Subject: Supplemental Response to Request for Additional Information and Submittal of Revision 2 of the Advanced NUHOMS® Storage System Application (TAC No. L23203)

SUPPLEMENTAL RESPONSE TO REQUEST FOR ADDITIONAL INFORMATION TRANSNUCLEAR WEST INC., TAC NO. L23203 (Supplement to TNW Letter DCS-TNW0105-12, dated 5/18/01)

**SAFETY ANALYSIS REPORT
FOR THE
STANDARDIZED ADVANCED NUHOMS®
HORIZONTAL MODULAR STORAGE SYSTEM
FOR IRRADIATED NUCLEAR FUEL**

**Revision 2
June 2001**

Figure 12.4-1
Minimum Spacer Disc Ligament Widths

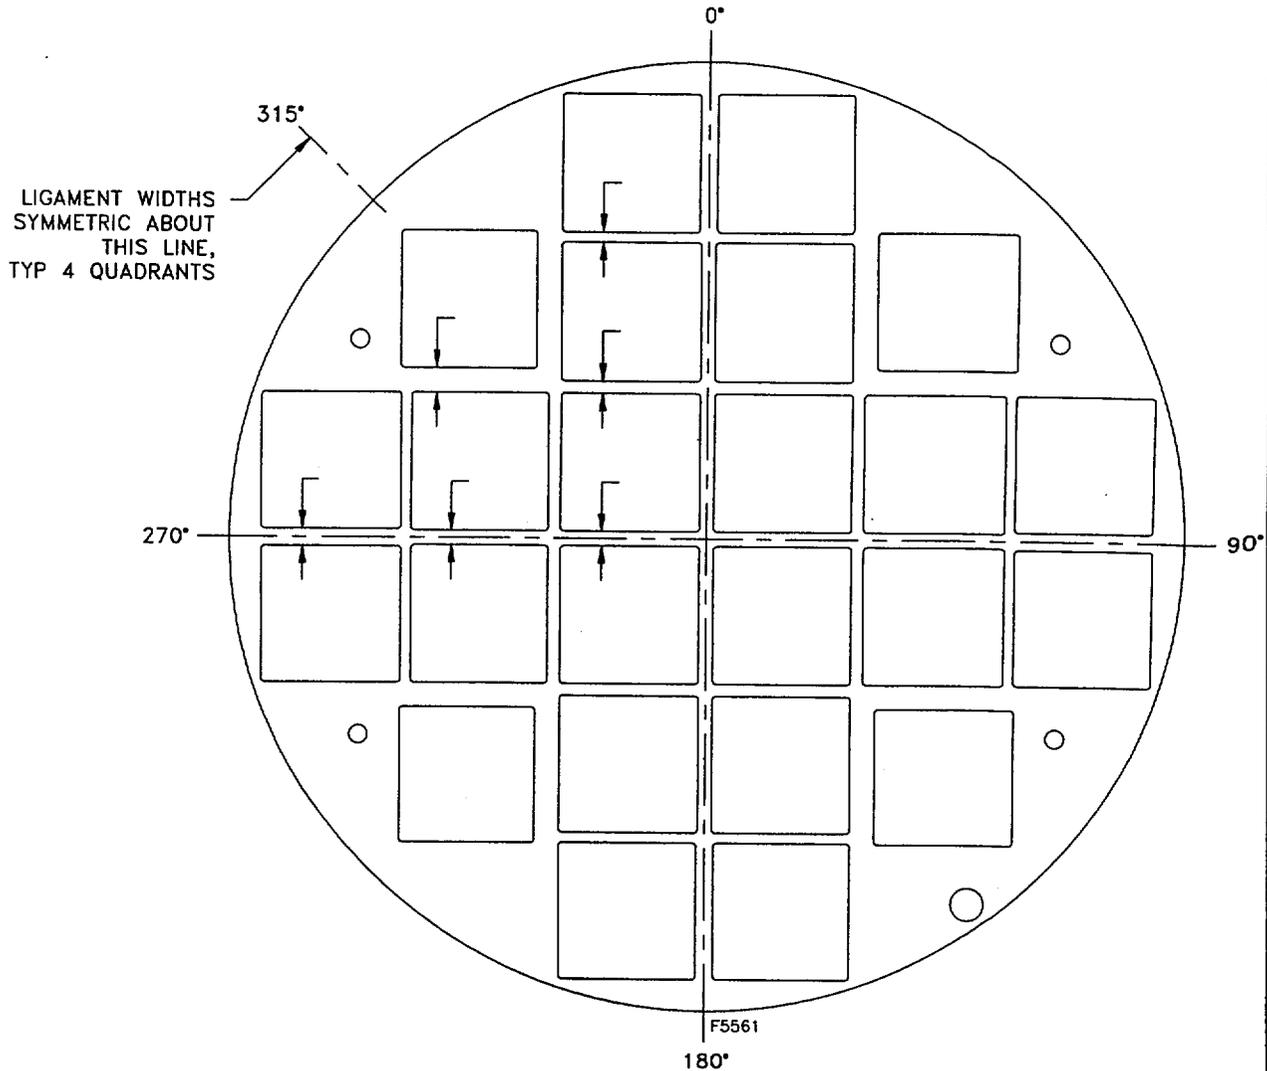
Revise Section 12.4.0 to include the basket B-10 loading and the flux trap size.

The B-10 loading and flux trap size are design parameters important to criticality safety. This is required by the staff to assess compliance with 10 CFR 72.24(g), 72.26, and 72.44(c).

Revise Section 12.4.0 to include the basket B-10 loading and the flux trap size.

SAR Section 12.4 has been revised to incorporate a new Section 12.4.2.3, titled "Canister Neutron Poison" which now specifies the minimum B-10 loading of 0.025 grams/cm². A new Section 12.4.2.4, titled "Canister Flux Trap Configuration" has also been added to specify the flux trap size.

12.4.2.4 Canister Flux Trap Configuration

The canister flux trap configuration is defined by the spacer disc ligament width dimensions. Figure 12.4-1 shows the location and dimensions of the ligaments (the dimensions shown in the one quadrant are applicable to all four quadrants).

SAR Section 12.4 has been revised to incorporate a new Section 12.4.2.3, titled "Canister Neutron Poison" which now specifies the minimum B-10 loading of 0.025 grams/cm². A new Section 12.4.2.4, titled "Canister Flux Trap Configuration" has also been added to specify the flux trap size.
